UNITED STATES DEPARTMENT OF COMMERCE
Patent and Trademark Office

APPLICATION NO.	FILING DATE	FIRST NAMED INVENTOR	ATTORNEY DOCKET NO.
09/430,792	10/30/99	JONES	M JONES003

Office Action Summary

DETAILED ACTION

FIG.-1C

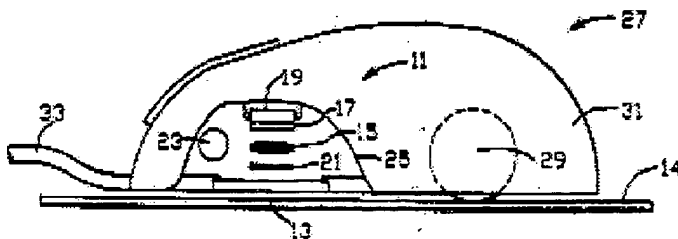
- a light unit projects light in the range of from 780 nm to 1000 nm onto an object (Fig. 1C shows light source 23 for projecting light onto an object 14, and col. 30, lines 25-26, discloses the light is an infrared light (i.e., from 750 nm to 1500 nm, which includes the range of from 780 nm to 1000 nm));

- a lens receives light reflected from said object and transmits said reflected light to an imaging device (Fig. 1C shows lens 15 receives light reflected from object 14 and transmits the reflected light to the photosensor array 19);

- said imaging device receives said reflected light and translates it into an electronic signal (Fig. 1C shows photosensor array 19 or colorimeter 11 for the translation of the light reflected from an object into an electronic signal as disclosed in col. 8, lines 56-60), said electronic signal is a video signal of the production of images of said object (col. 1, lines 21-22, discloses the colorimeter used for assessing the color of the object produced on a video screen, implying a video signal of the production images of the object).

- at least one filter (Fig. 1C shows variable wavelength filter 17).

- the object is a fault and the reflected light received by said imaging device comprises light in the range of from 780 nm to 820 nm (Fig. 1C shows the object 14 is a fault and the reflected light received by said photosensor array 19 comprises light in the range of infrared light as disclosed in col. 30, lines 25-26 (i.e., from 750 nm to 1500 nm, which includes the claimed range of from 780 nm to 820 nm).

- light source emits light in said desired range (Fig. 1C shows light source 23 emits light in said desired range of from 385 nm to 725 nm as disclosed in col. 12, lines 19-39).

- a non-coherent light source for generating light (Fig. 1C shows light source 23 for generating light);
- filter means for filtering said generated light, wherein said filter means permits the passage of light in the range of from 800 nm to 950 nm (Fig. 1C shows variable wavelength filter 17 for filtering the generated light, and col. 30, lines 17-26, discloses the filter permits the passage of the light in the range of infrared light (i.e., from 750 nm to 1500 nm, which includes the claimed range of from 800 nm to 950 nm));

- an imaging means for the translation of visible and infrared light reflected from an object into an electronic signal (Fig. 1C shows photosensor array 19 or colorimeter 11 for the translation of the light reflected from an object into an electronic signal as disclosed in col. 8, lines 56-60, and col. 30, lines 25-26, discloses that the light is visible and infrared light), said electronic signal is a video signal of the production of images of said object (col. 1, lines 21-22, discloses the colorimeter used for assessing the color of the object produced on a video screen, implying a video signal of the production images of the object).

FIG.-9

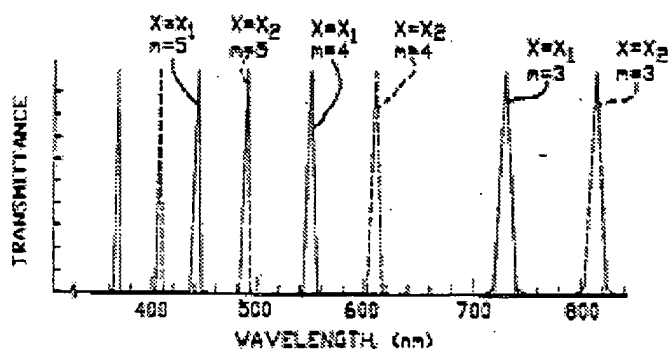
- said infrared is near infrared light (Fig.

9 shows the wavelength of the light is between 700 nm and 800 nm, which is in the range of near infrared light (i.e., 750 - 1500 nm).
